SERVICE BULLETIN

Service Bulletin No.: DA20-92-02, Rev. 0

Title: Certification, Spanish Import Requirements

Figure 1
Exterior Placards Installation

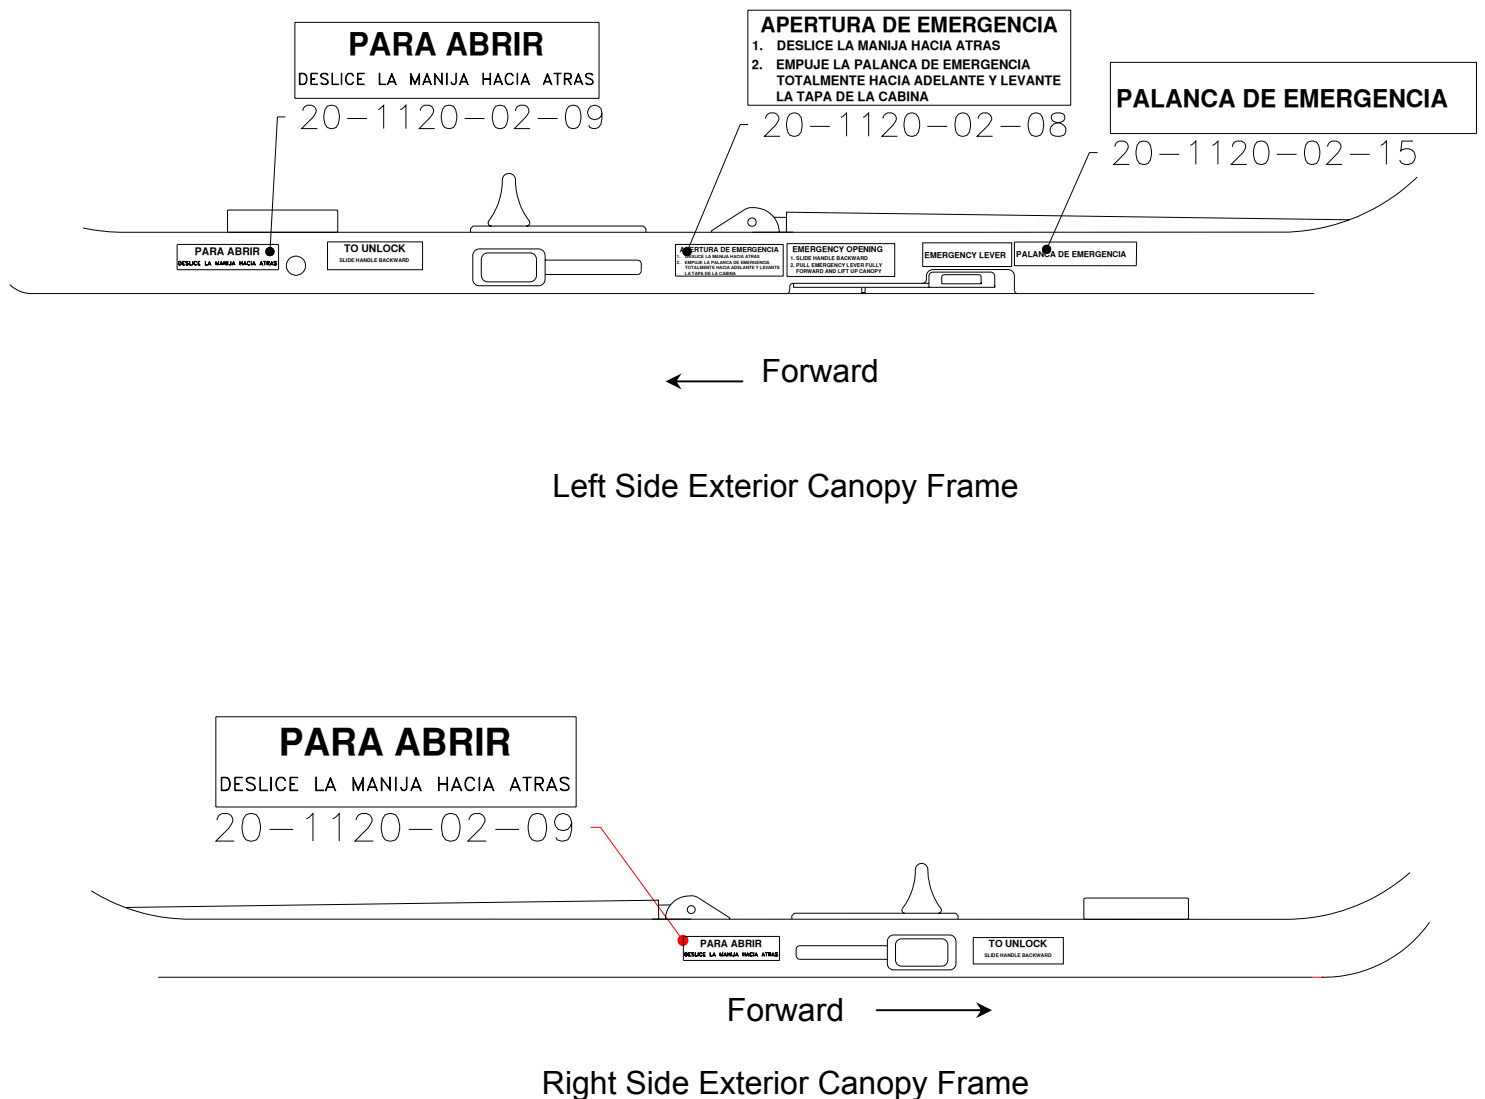
- 10.1 Install the Spanish language placards adjacent to the English language placards as shown in Figures 1,2 and 3.
